DEVELOPMENT REVIEW BOARD REPORT

Vargo Quarter Horses (VQHS) 21-DR-2002#2 | Request for approval of an updated site plan and building elevations for an amendment to previous case 21-DR-2002 for an existing Ranch.

21-DR-2002#2

SITE PLAN

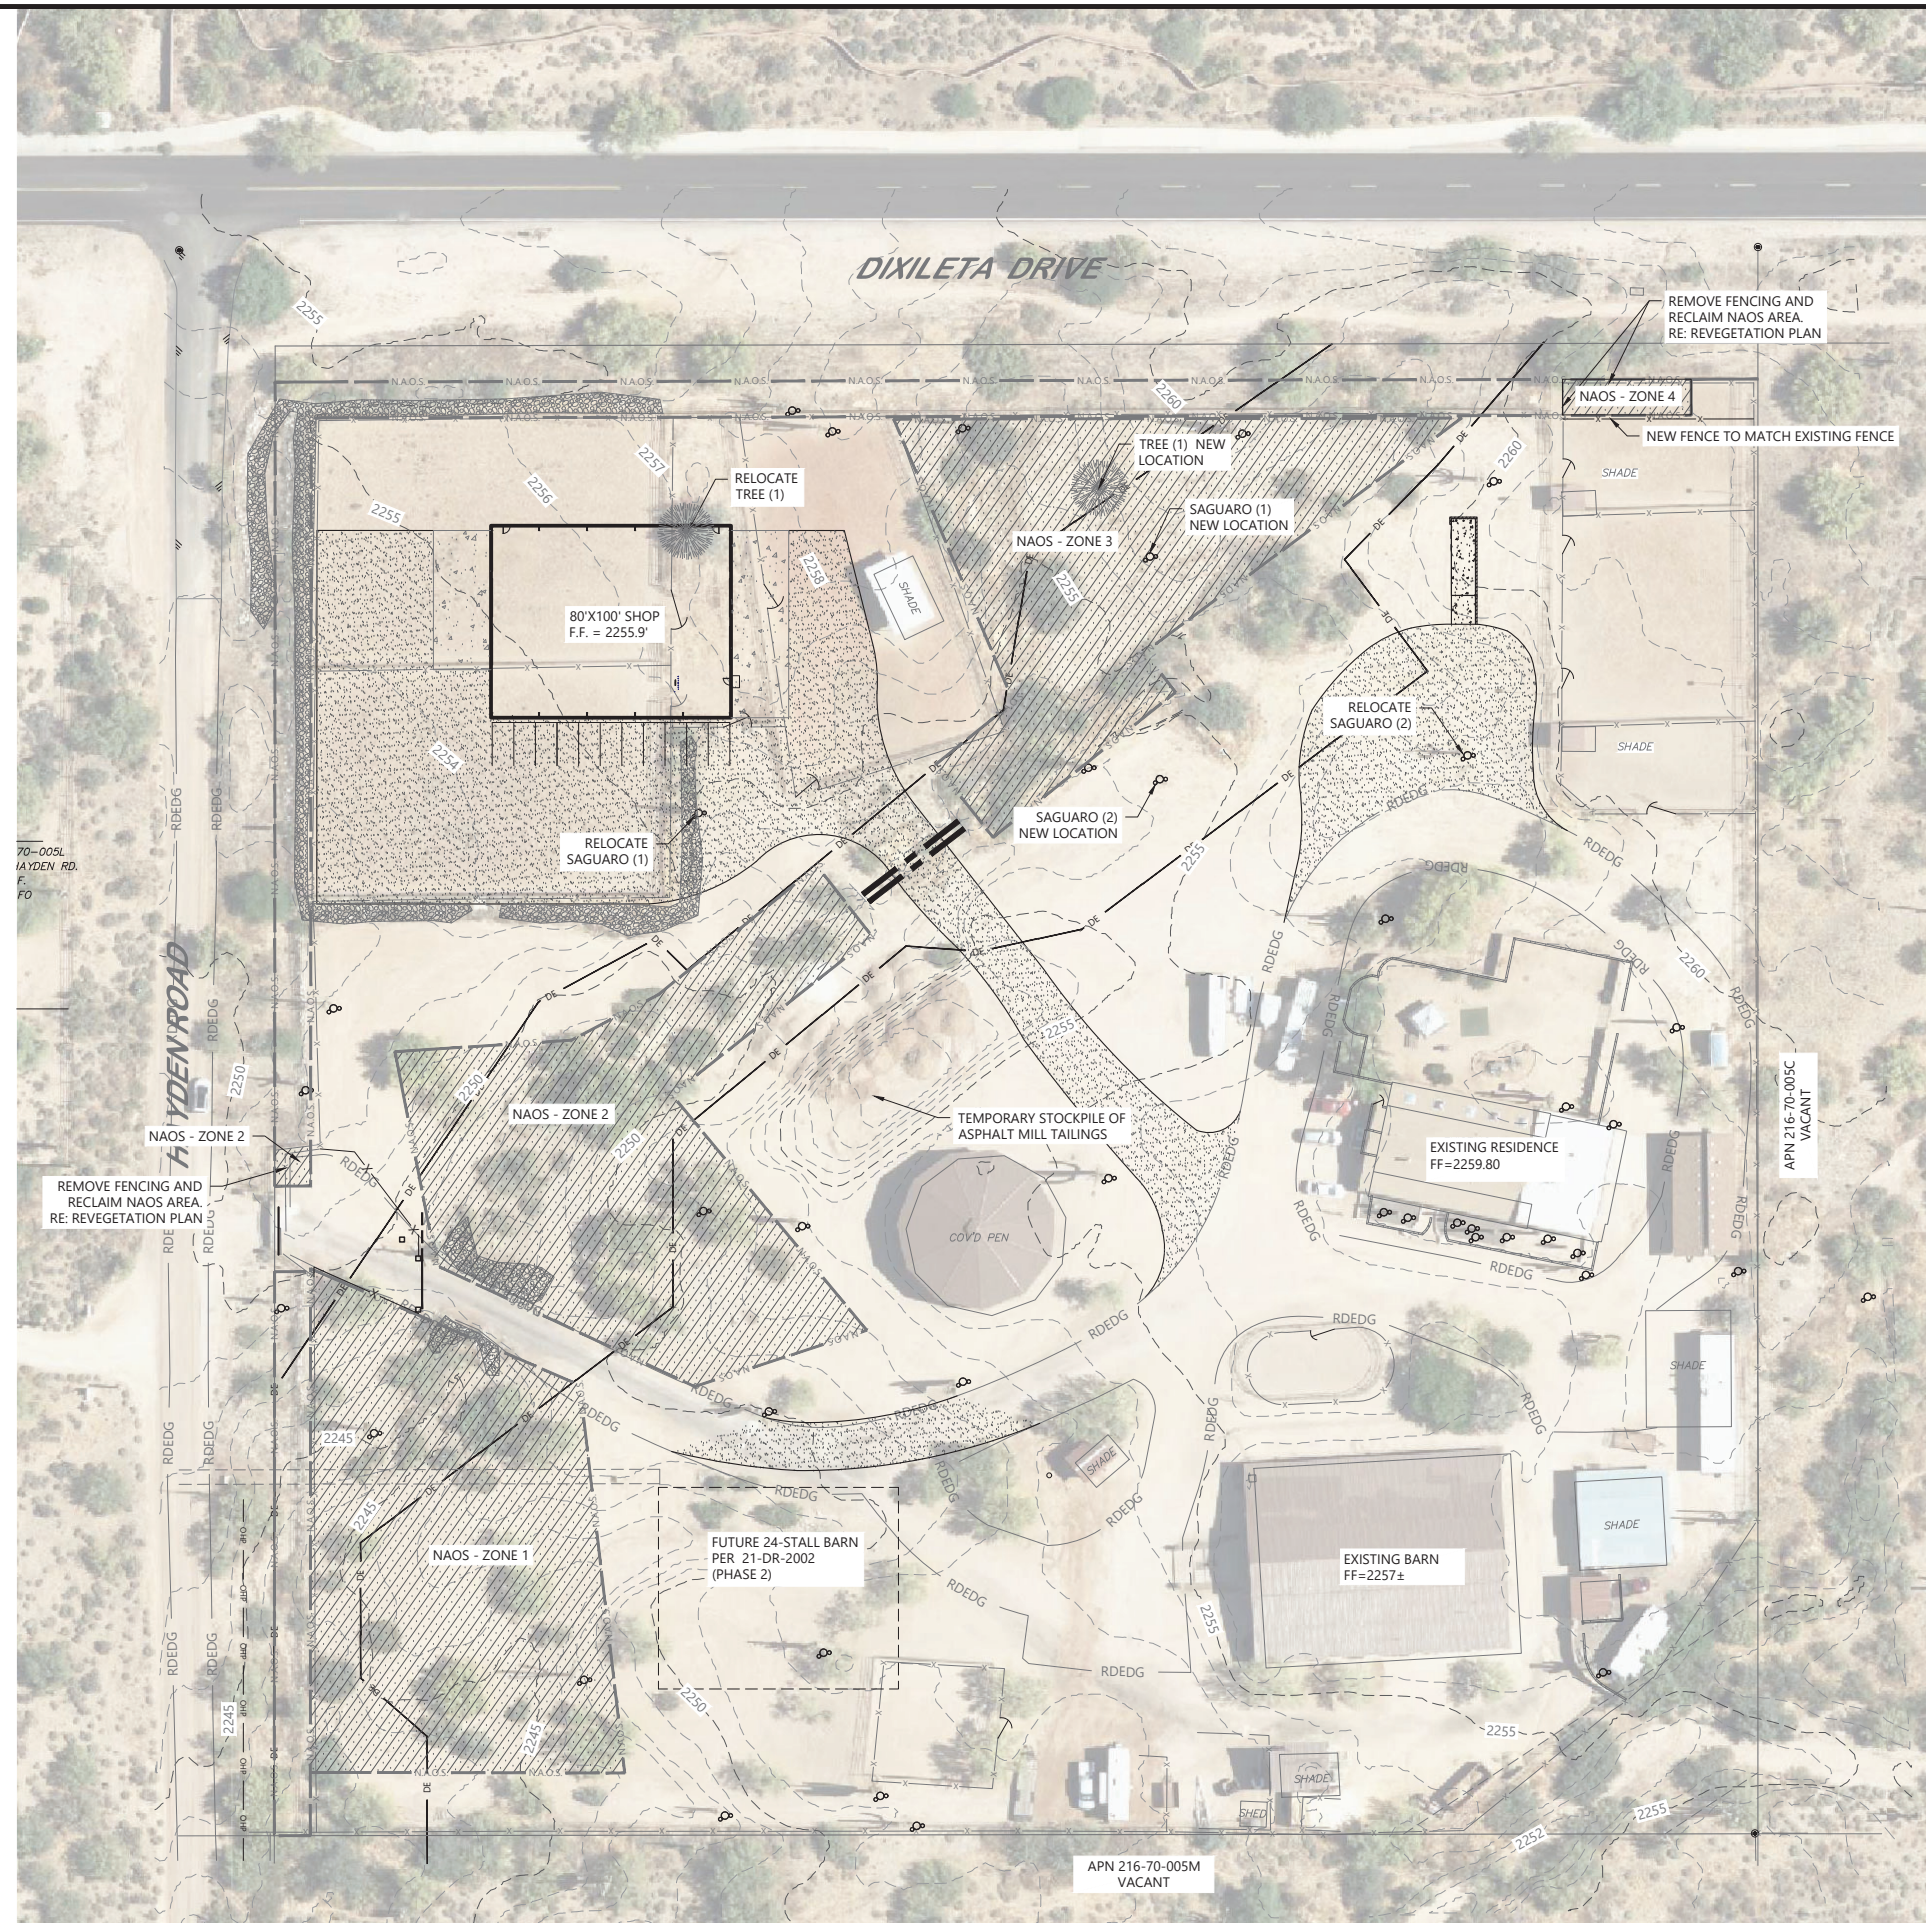
- *Staff finds the proposal improves the existing access to the site by relocating the gated entry beyond the required front yard setback to provide more queuing distance for vehicles waiting for the gate to open.*

- b. The location and configuration of all site improvements shall be consistent with the site plan submitted by Western Heritage Consulting Engineering, with a city staff date of 4/29/2024.

VARGO QUARTER HORSES, LLC
SHOP ELEVATIONS
CITY OF SCOTTSDALE, AZ

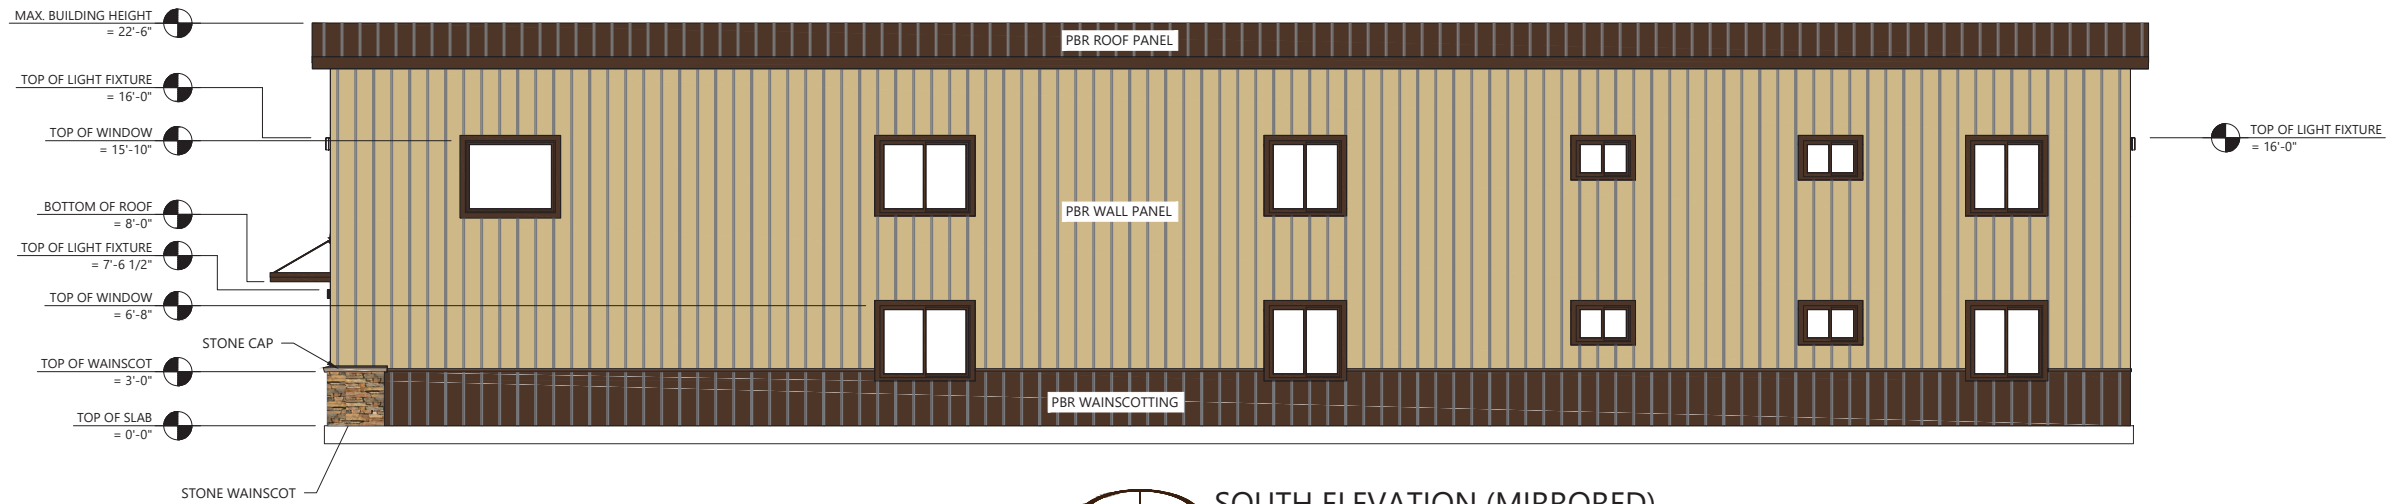
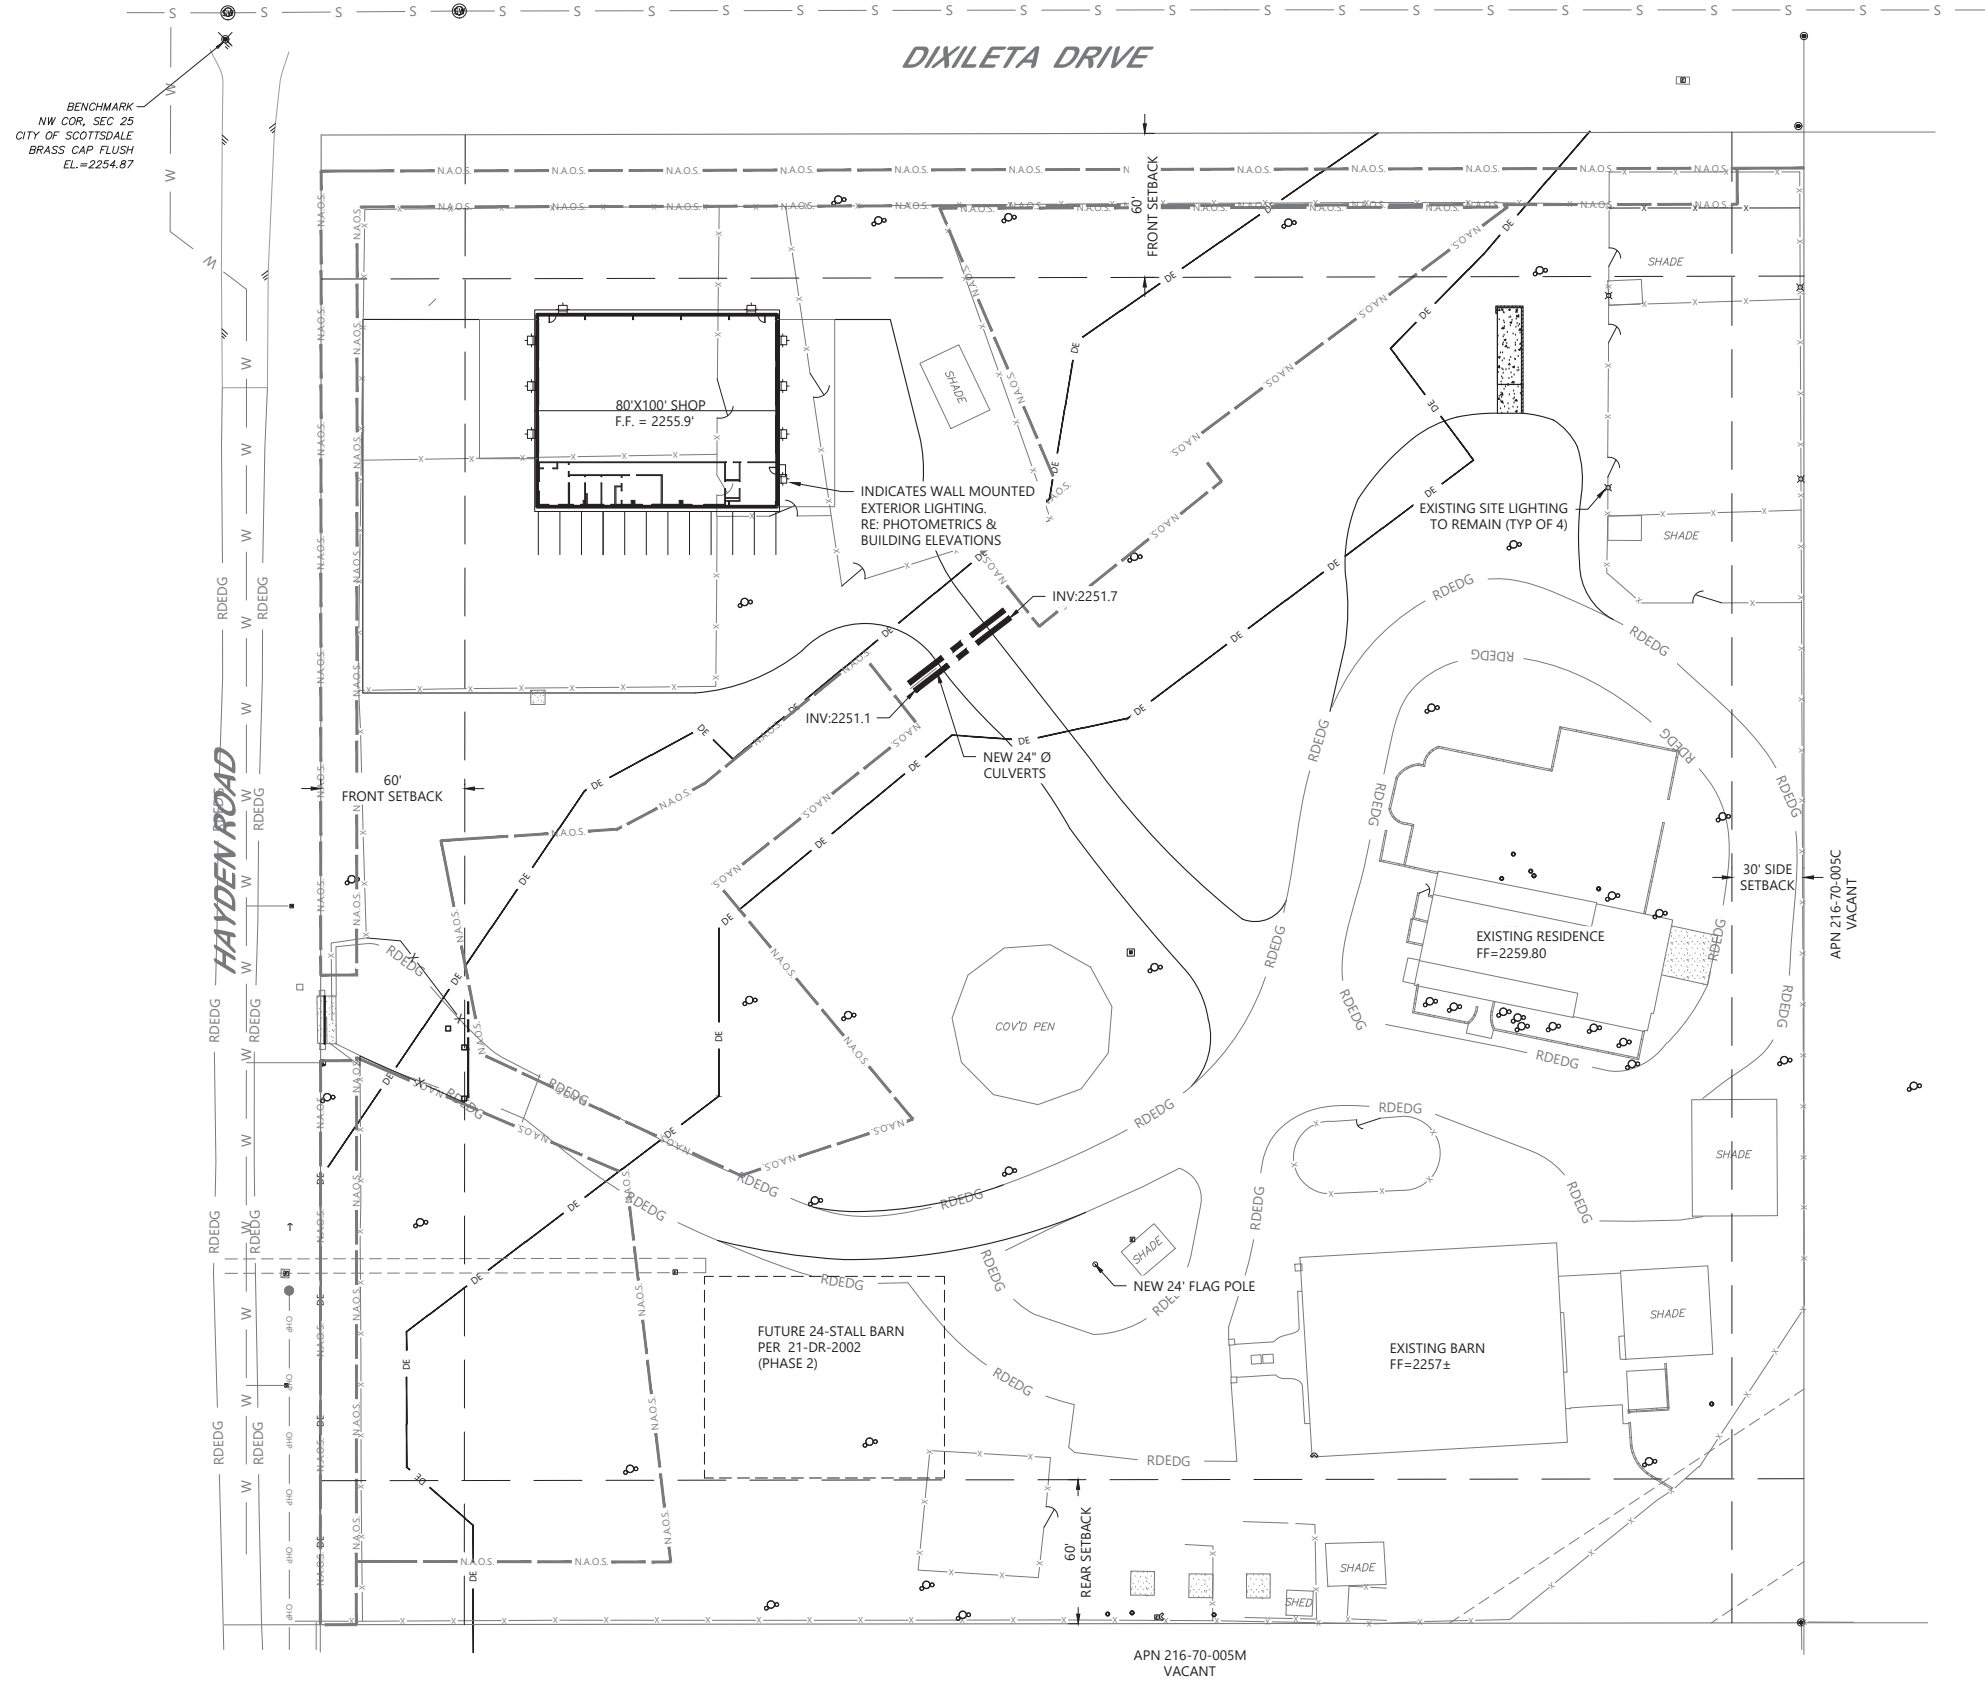
The proposed improvements include maintaining the areas dedicated to NAOS including some lower scale plant material revegetation improvements to meet design standards. Additionally, a portion of the site will be re-established as NAOS per the previously approved development.
 - *Staff finds the proposed building utilizes colors and materials that are consistent and conforming to the ESL and FO zoning and applicable design guidelines, providing stone and paint colors that convey muted earth tones. The positioning of the new structure respects the*

2. All exterior window glazing shall be recessed a minimum of fifty (50) percent of the wall depth, including glass windows within any tower/clerestory elements. The amount of recess shall be measured from the face of the exterior wall to the face of the glazing, exclusive of external detailing. With the final plan submittal, the developer shall provide head, jamb and sill details clearly showing the amount of recess for all window types.
3. All exterior doors shall be recessed a minimum of thirty (30) percent of the wall depth, the amount of recess shall be measured from the face of the exterior wall to the face of the glazing, exclusive of external detailing. With the final plan submittal the developer shall provide head, jamb and sill details clearly showing the amount of recess for all door types.
